CHANGE ORDER

PROJECT:
 Precint 2 - Mobility Projects
 Brand Lane - From Avenue E to US90A
 Fort Bend Count Project 718-769

CHANGE ORDER NUMBER	4
DATE	12-14-15
PROJECT NUMBER	718/769
	Fort Bend County
CONTRACT FOR	
CONTRACT DATE	10-1-14
FBC PURCHASE ORDER NO	116140

FORT BEND COUNTY PROJECT 718/769
BRAND LANE - FROM AVENUE E TO US90A
Change Order 4 - Option A for Bore Under Highway 90

Original Plan

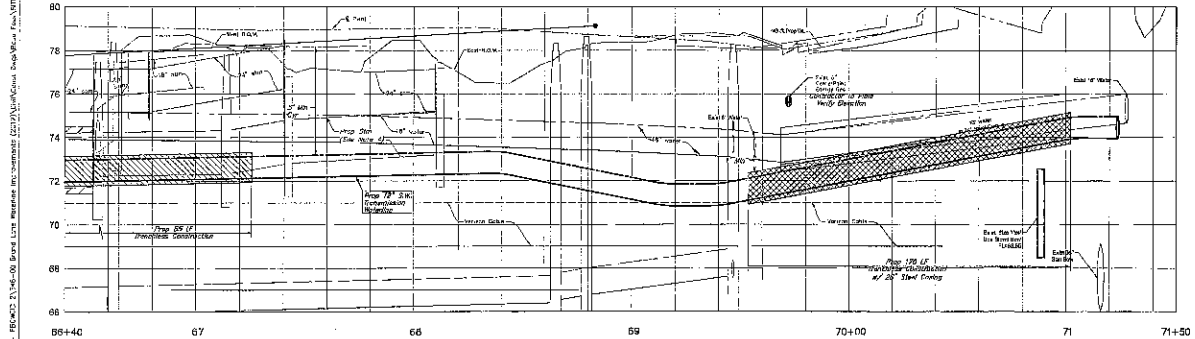
The contract is changed as follows:
 Revised 12" SW Transmisson plans to follow new "Option A Plan." The reason for the change is that an existing 16" waterline was verfyied to be 2 feet lower than original plans determined. The elevation of the waterline has been revised per Option A Plans. Please see attached plans original and Revised Option A.

the board approved the bore changes for the shallow option A. you are good to go from the district's aspect.
